MEETING NOTICE AND AGENDA
MANSFIELD INLAND WETLANDS AGENCY

Monday, May 2, 2016 ■ 6:30 PM

Date: April 27, 2016
To: Mansfield Inland Wetlands Agency
From: Jennifer Kaufman, Inland Wetlands Agent
Subject: 91 & 93 Meadowbrook Lane (File #W1562)
Uniglobe Investments, LLC
Description of work: construction of 36 dwelling units
Map Date: 1/8/2016, revised through 4/11/2016

BSC has completed its review of the applications for a Special Permit and Inland Wetlands license for the proposed 36 unit apartment complex known as Meadowbrook Gardens located at 91-93 Meadowbrook Lane in Mansfield, Connecticut. This letter report summarizes our findings and presents comments and questions that we have formed as a result of the review. This review encompasses the Project's compliance with the Town of Mansfield Zoning Regulations, Town of Mansfield Inland Wetlands & Watercourses Regulations, Town of Mansfield Engineering Standards and Specifications, 2004 Connecticut Stormwater Quality Manual and the 2002 Connecticut Guidelines for Soil Erosion & Sediment Control, and general engineering and best development practices.

CONN. STATE STANDARD CATCH BASIN
NO SCALE

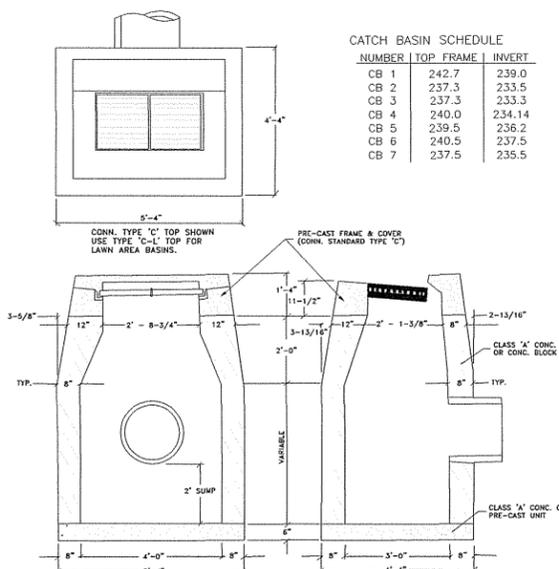
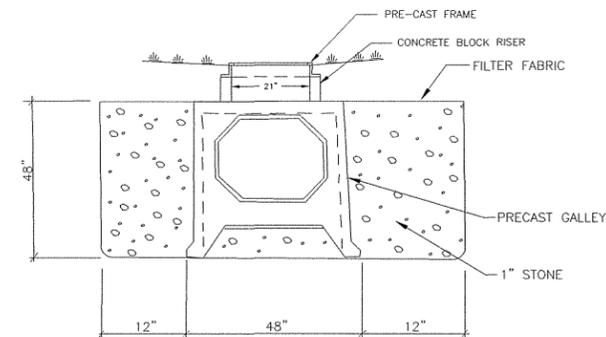
7. Catch Basin – 4 is designed to have a TF = 236.7. Based upon the design contours at CB-4, the proposed grade is approximately 240. We recommend this be reviewed and the top of frame grade revised as appropriate.

9. We recommend that a detail of the emergency spillway at the small basin located west of the main entrance drive be provided.
10. Catch Basin – 7 has been designed to be at the low point of the paved area and it has been designed with a modified rip rap overflow to prevent erosion of the hill during large storm events, during which the leaching galleys/existing soil do not have the volume/percolation to prevent runoff from leaving the site. By our computations, the large storm events (50-year and up) will overflow and, during those events, the entire paved drive to the “238” contour will be ponded. We recommend, as a safety measure in lieu of the rip rap overflow down the entirety of the slope, that CB-7 be designed with a 12” outlet pipe at elevation 236. The outlet pipe would extend approximately 30’ to the bottom of the slope and be fitted with a concrete flared end and rip rap outlet control. We recommend this be designed per the 2000 ConnDOT Drainage Manual standards and a detail be provided.

TEMPORARY SEDIMENT TRAP #1 DETAIL
NOT TO SCALE

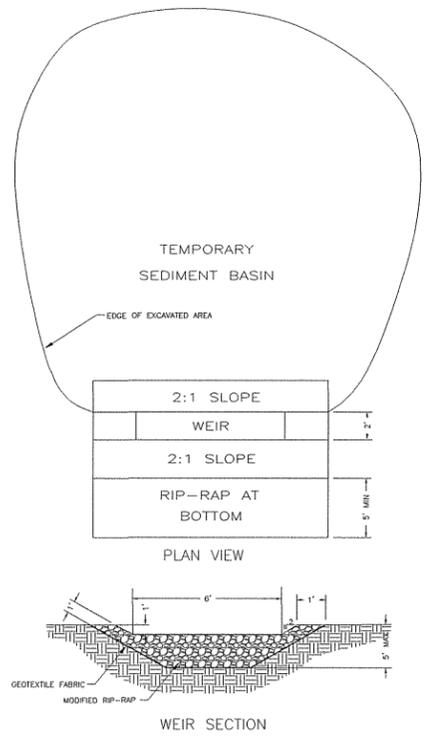
13. Although the plan calls for the use of temporary sediment traps, we do not see a detail of one. We recommend placing a temporary sediment trap detail, as shown on page 5-11-25 of the 2002 Connecticut Guidelines for Erosion & Sediment Control, on the plans.
